UNITED STATES PATENT AND TRADEMARK OFFICE

10/706,947

Office Action Summary	Application No. 10/706,947	Applicant(s) NELSON, THOMAS J.	
	Examiner William V. Gilbert	Art Unit 3635

DETAILED ACTION

Figure 4B from Wright

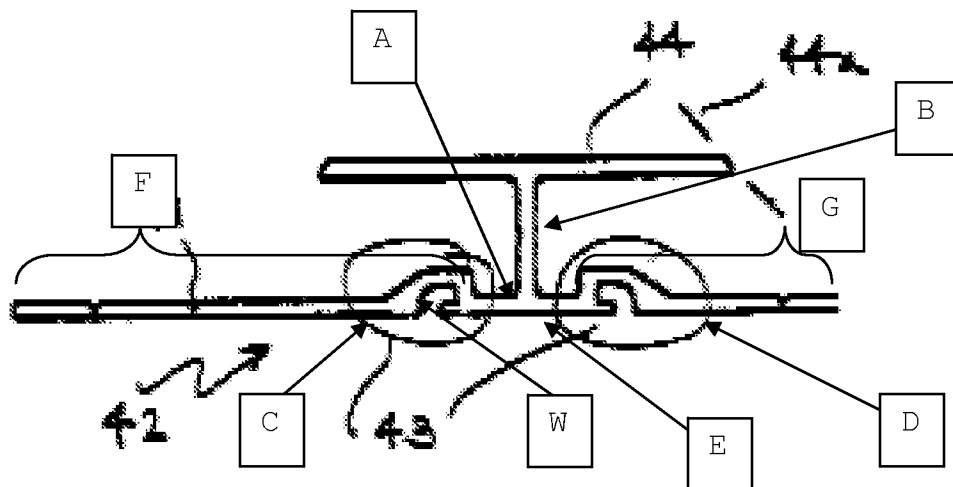
Claim 1: Wright discloses a disengageable connector for interconnecting panels comprising a body (see attached Fig. 4B from Wright below) including a base ("A") and projection ("B") extending from the base, the base has top and bottom surfaces (portions "F" and "A" denote the top surface and proximate "W" is the bottom surface, respectively), the underside has first, second and third footing members ("C", "D" and "E" below, respectively) first and second protrusions ("F", "G", respectively), the protrusions are spaced from the projection and located on either side of the projection, the first and second footing members are beneath the first and second protrusions and the third footing member is beneath the projection, the footing members are spaced by recesses (proximate 43) extending fully between the members. The language, "shaped and dimensioned to compress...foam pad" is a statement of intended use of the claimed invention and must result in a structural difference between the claimed invention and the prior art in order to patentably distinguish the claimed

Claim 2: the projection extends vertically from the top surface of the base (as shown), the member has top and bottom portions (e.g. 44 is the top portion) and right and left halves (as shown). The limitation "for insertion into edges...connected" is a statement of intended use of the claimed invention and must result in a structural difference between the claimed invention and the prior art in order to patentably distinguish the claimed invention from the prior art. If the prior art structure is capable of performing the intended use, then it meets the claim.

Claim 4: Wright discloses a disengageable connector comprising a longitudinally extending connector body having a similar profile along its entire length, the connector has a base ("A") and a projection ("B") extending from the base, the

base has top and bottom surfaces (as described in rejection above), first, second and third footing members ("C", "D" and "E") extending downwardly from the bottom surface of the base, first and second protrusions ("F" and "G") extending vertically from the base, the protrusions are spaced apart from the projection and are located on either side of the projection, the footing members are beneath the protrusions and projection, respectively. The limitation "shaped and dimensioned...foam pad" is a statement of intended use of the claimed invention and must result in a structural difference between the claimed invention and the prior art in order to patentably distinguish the claimed invention from the prior art. If the prior art structure is capable of performing the intended use, then it meets the claim. Wright does not disclose the actual depth of the footing members as approximately 0.036 inches in depth. It would have been obvious at the time the invention was made to a person having ordinary skill in the art as a matter of design choice to have the dimensions footing members as claimed as claimed because applicant failed to state a criticality for the necessity of the limitation and the prior art of record is capable of being designed to meet the limitation as claimed and maintain within the scope of the invention. See MPEP 2144.04(IV)(A) citing *Gardner v. TEC Systems, Inc.*, 725 F.2d 1338 (Fed. Cir. 1984),

Claim 5: the protrusions extend substantially the entire length of the connector (as shown).

Claim 16: Wright discloses a connector for interconnecting panels comprising a body with a base ("A") having a longitudinal extent with a first and second end, the connector further includes a projection ("B") extending from a top surface of the base and having a central stem ("shown by arrow "B") with first and second outwardly extending members (44) extending from the stem, first and second protrusions ("F" and "G", the protrusions extend vertically from portion indicated as "A") extending from the base adjacent a first edge, and the protrusions decrease in height (see portions indicated by proximate 43) as it extends from the center of the base towards the edge of the base.

Claim 18: the base includes first and second footing members ("C" and "D") extending downwardly from the bottom surface ("W"), the footing members extend the entire length of the base (as shown). The language "shaped and dimensioned...second protrusion" is a statement of intended use
